**SERVICE BULLETIN**

ENGINE - IGNITION - INTRODUCTION OF A REDIMENSIONED IGNITION LEAD COOLING SHROUD AND  
THE DELETION OF IGNITION COOLING BOX SUPPORT BRACKET - CATEGORY CODE 5 -  
MOD.ENG-74-0003

**V2500-ENG-74-0003**

Removal/Installation of the Ignition Cooling Box and the improved Cooling Shroud for  
Exciter End (V2500-A1, -A5 and -D5)  
Fig.9

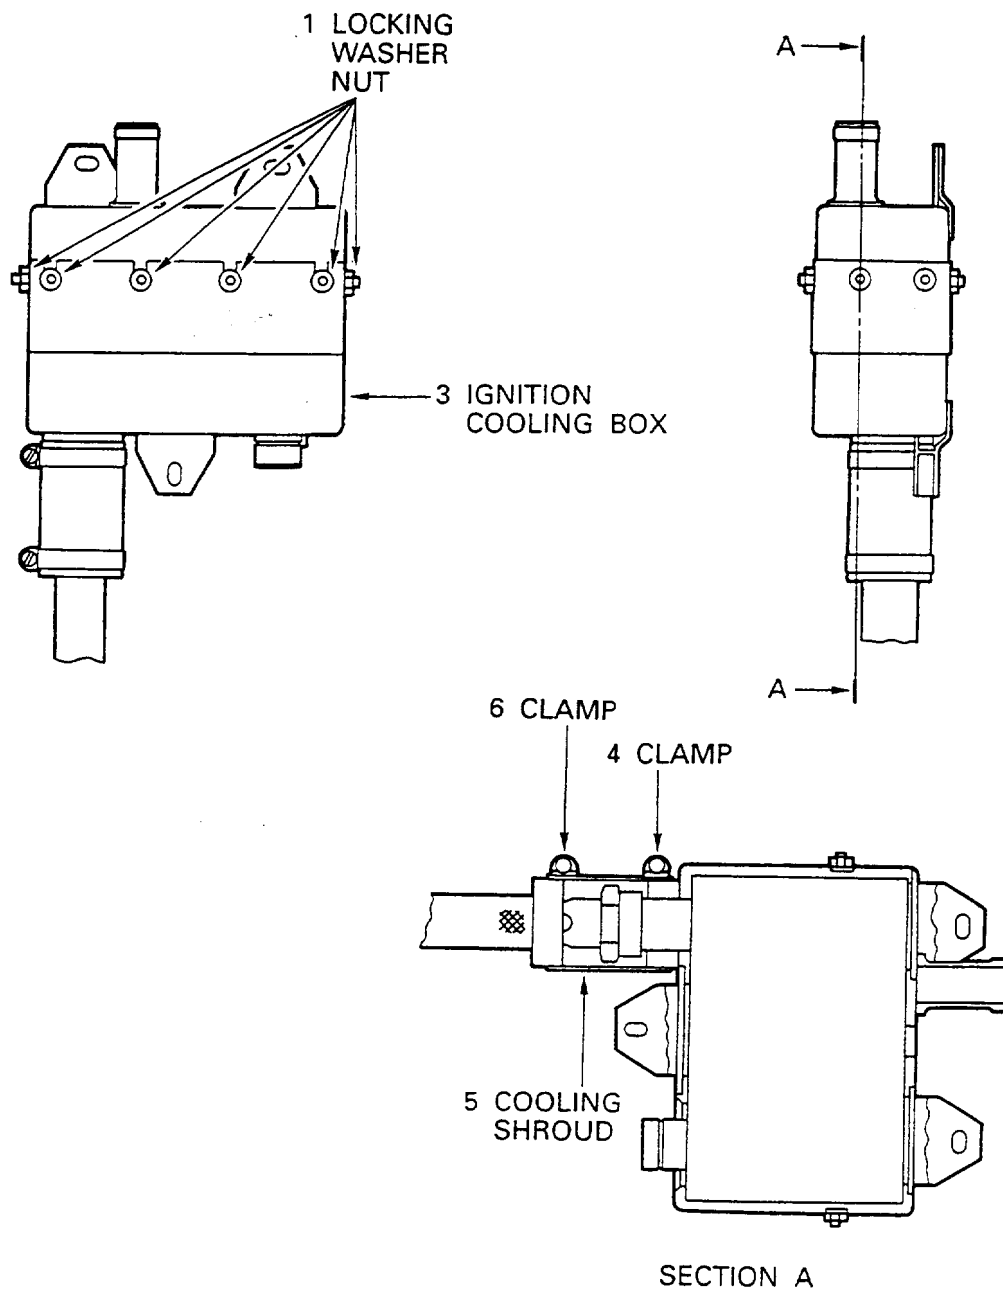
- (6) Install the improved Cooling Shroud for Exciter End (See Figure 9).
  - (a) Install the Cooling Shroud (5) (74-11-38, 01-030 and 02-030, PN 5U0071) onto the connection between the Ignition Exciter and the Ignition Lead.

(6) Install the improved Cooling Shroud for Exciter End (See Figures 9, 10 and 12)

(a) Install the Cooling Shroud (5) (74-21-43, 01-030) or 02-030, PN 5U00712) onto the connection between the Ignition Exciter and the Ignition Lead.

before and after alteration for the Ignition Cooling System (V2500-A1, -A5 and -D5)  
Fig.10

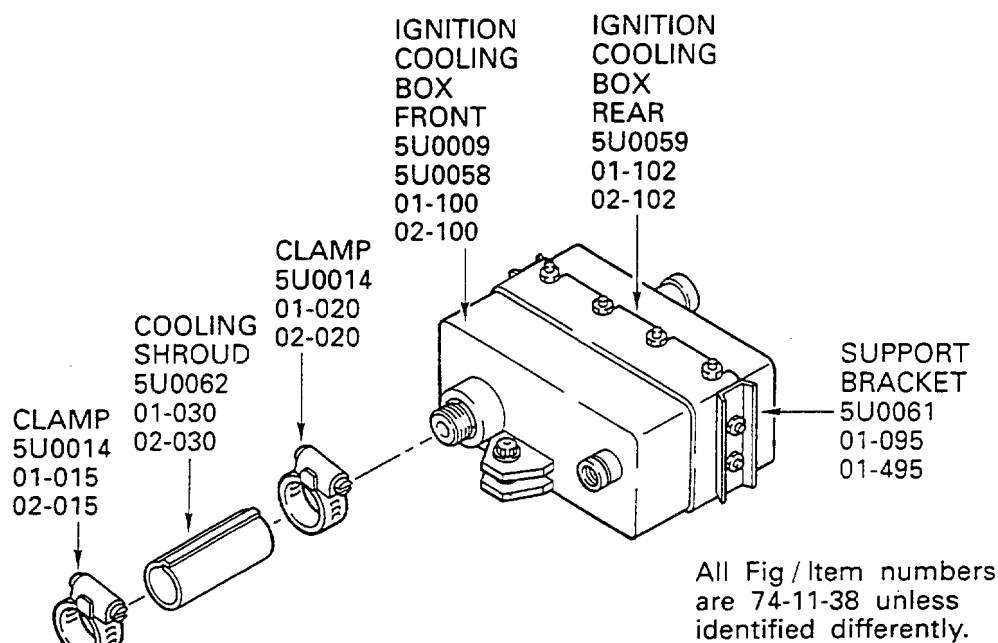
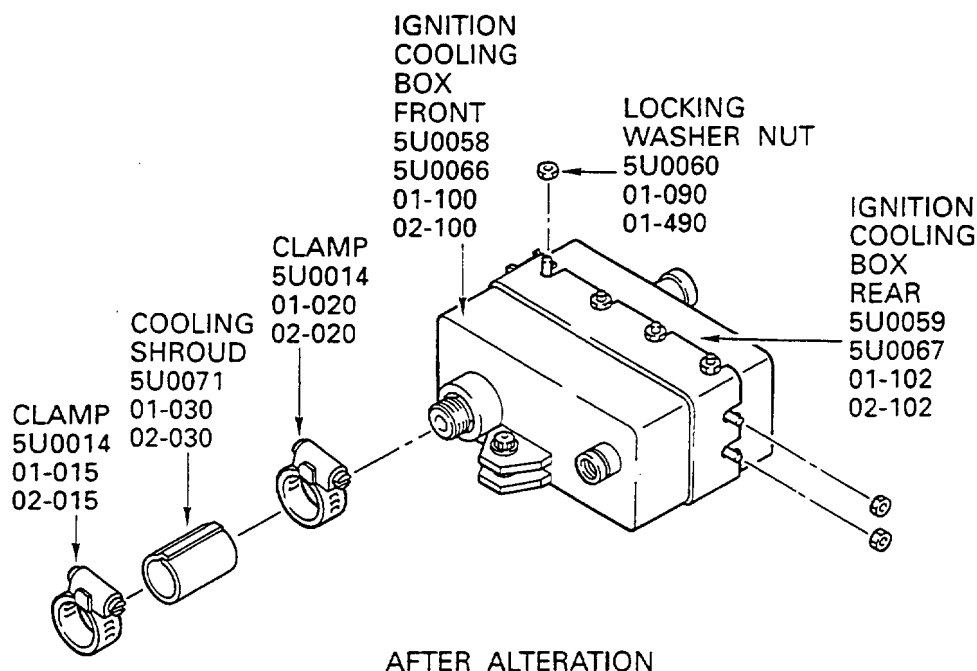
- (a) Move and change the adaptor of the Ignition Lead.
- (b) Reduce length of the Cooling Shroud for Exciter End.
- (c) To eliminate the Support Brackets on the Cooling Box.

(c) To remove the support bracket from the cooling boxes, if the Service Bulletin No. V2500-ENG-74-0002 Revision 1 has been applied.

(8) Remove the four (4) nuts (1) (74-11-38, 01-090 and 01-490, PN 5U0060) which installed the Support Bracket (See Figure 9).

(9) Remove and discard the Support Bracket (74-11-38, 01-095 or 01-495, PN 5U0061) (See Figure 10).

Installation of the Cooling Box (V2500-A1 and -A5)  
Fig.11

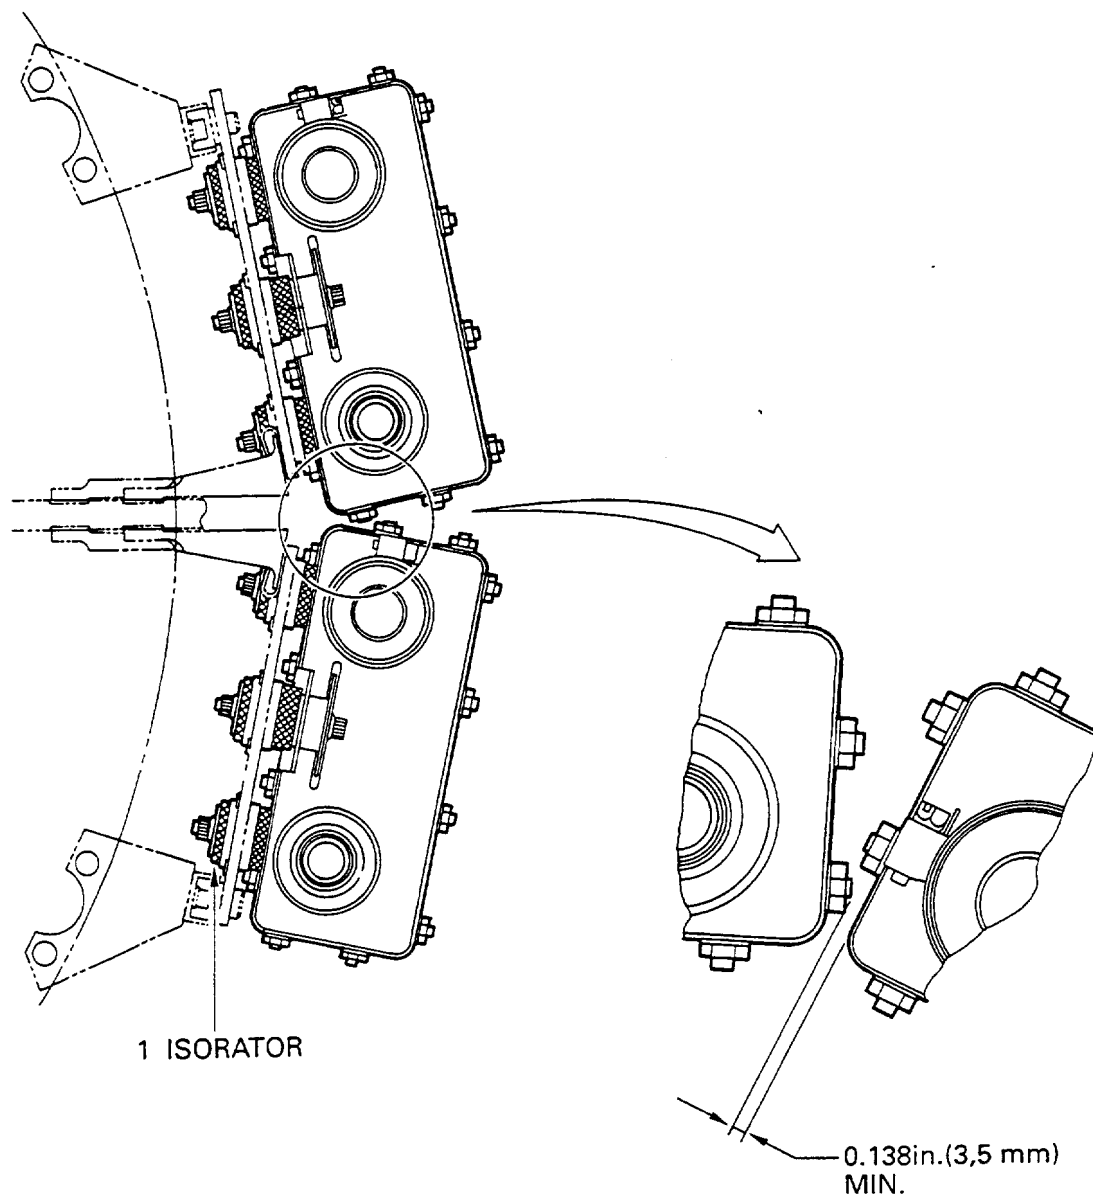
4. Keep clearance between each ignition system minimum 0.138 IN (3.5 MM) without applying any force to isolators (1) (See Figure 11).
  5. TORQUE the bolts (50) to between 36 and 45 lbf in (4.1 and 5.0 Nm) (refer to 1.K.(3)).

Installation of the Cooling Box (V2500-D5)  
Fig.12

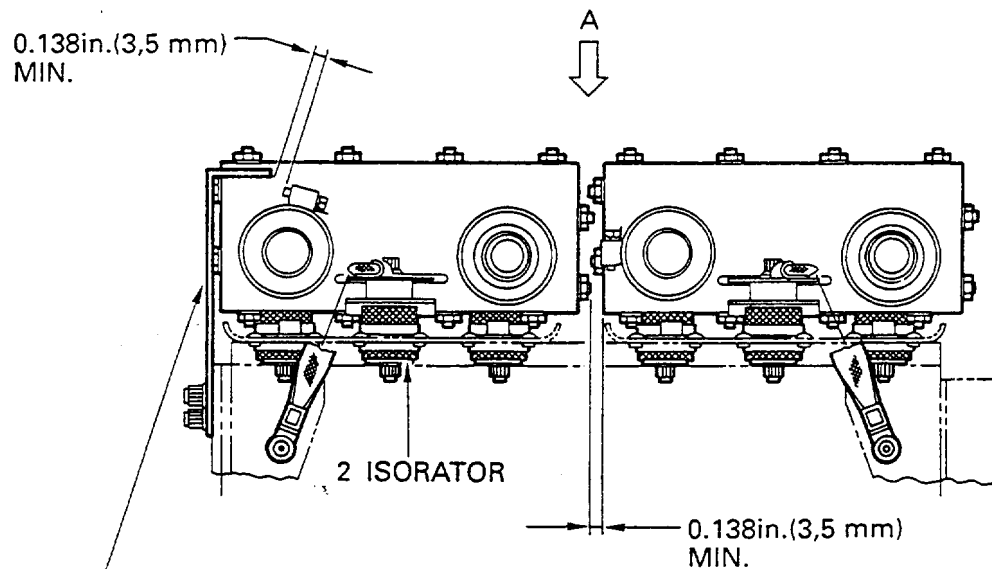
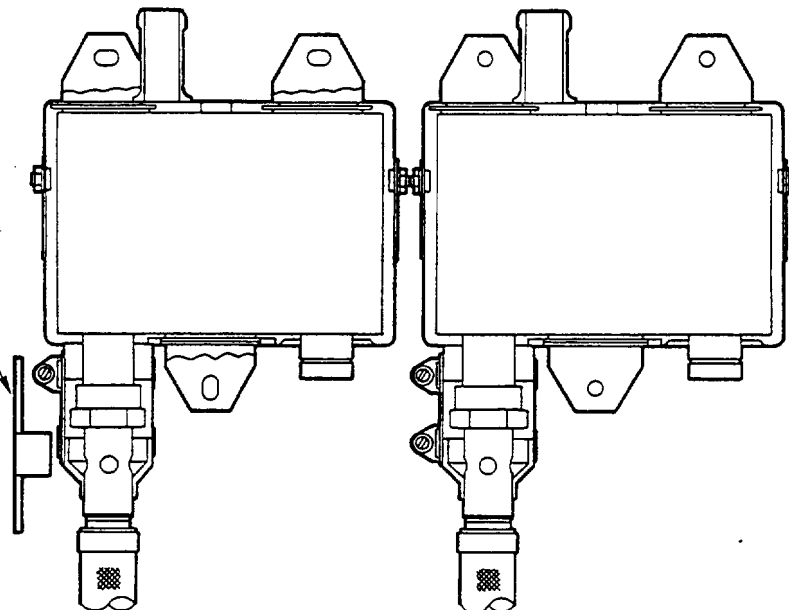
2. Install the bonding strap (63) onto the lower forward bolt (57).
  3. Install the bolts (57) and the nuts (62).
  4. Keep clearance between each ignition system minimum 0.138 IN (3.5 MM) without applying any force to isolators (1).  
The ignition systems to be moved engine forward as much as possible within keeping the 0.138 IN (3.5 MM) clearance for the instructions of 2.B.(6).(c) (See Figure 12).

NOTE: To keep clearance between clamp (6) and small bracket (72-41-00, 03-860) minimum 0.138 IN (3.5 MM) and the small bracket to be moved engine upward (See Figure 12).
